**Direction GEHW-SN112017
Revision 2**

NGPDU Gantry Switch Upgrade Procedures

NGPDU GANTRY SWITCH UPGRADE PROCEDURES

Figure 1 NGPDU Gantry Switch Upgrade Overview

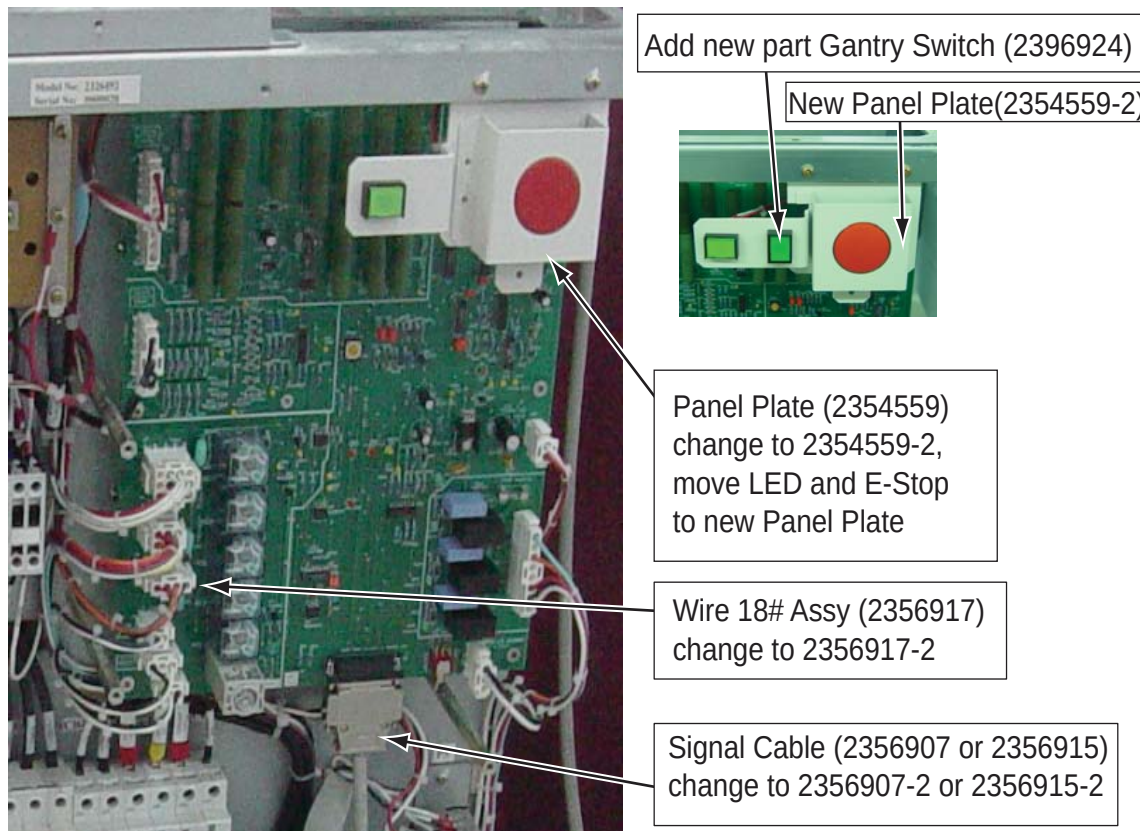
As old version NGPDUs have no Gantry Switch, FEs have to open the Gantry cover when they want to turn on/off the Gantry power. To resolve this problem, Gantry Switch is added. This Service Note describes how to install Gantry Switch on old version NGPDU, NGPDU-2, NGPDU-3 which are without this function.

Order the Gantry Switch Update Kit Assy (SN: 5136702, refer to [Table 1](#)) and follow the procedures in Section 3.2. [Figure 1](#) gives a pictorial overview of the installation.

Figure 2 Connect Cables to Gantry Switch

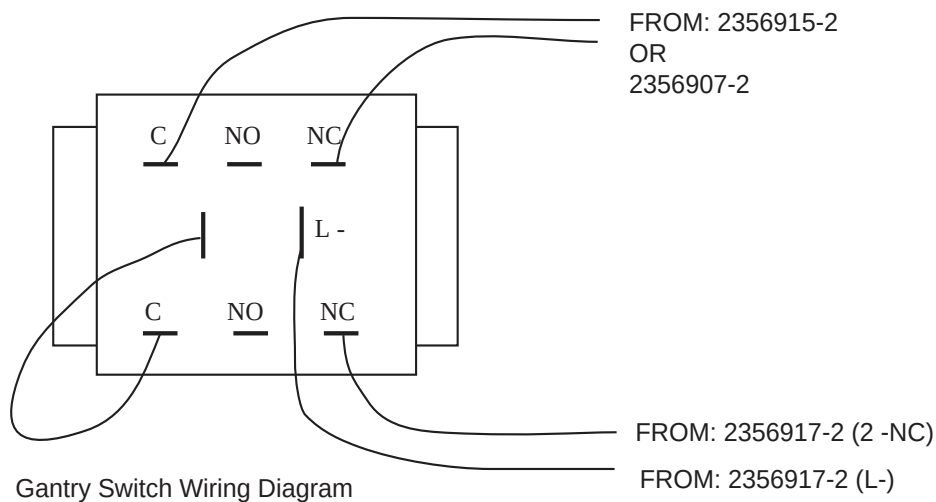
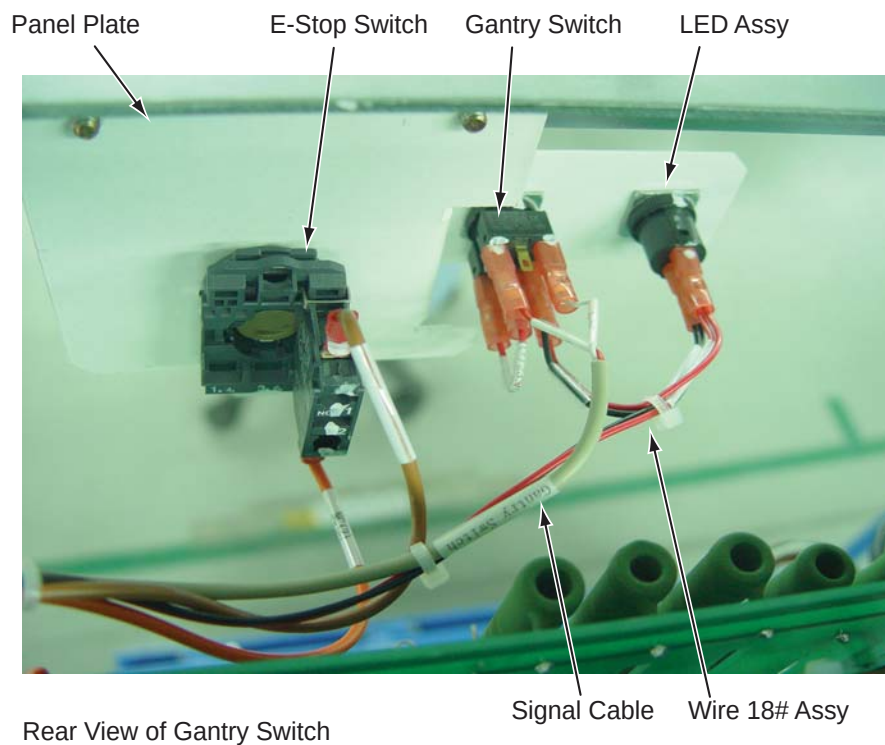
- Install original E-stop switch, LED Assy and new part Gantry Switch (2396924) to the new Panel Plate (2354559-2).
- Link Signal Cable (2356907-2 or 2356915-2) to Gantry Switch (2396924), PDU Control

- e.) Connect new Wire 18# Assy (2356917-2) to Emergency Stop Switch, Lamp, Gantry Switch and PDU Control Board.

Figure 4 Routing Cables

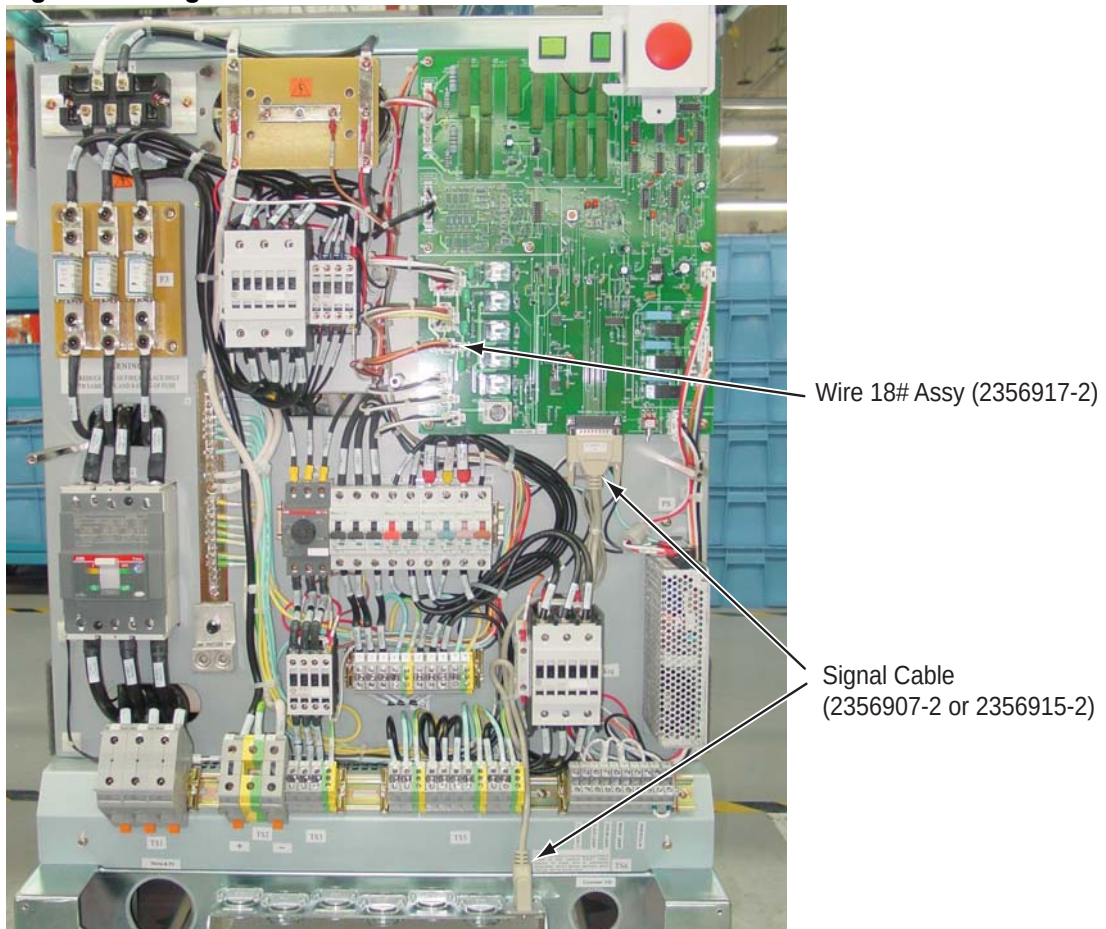
- f.) Install the new Panel Plate (2354559-2) on the PDU.
- g.) Route the cables as shown in [Figure 3](#) and [Figure 4](#). Bundle and fasten the cables with tie-wraps.
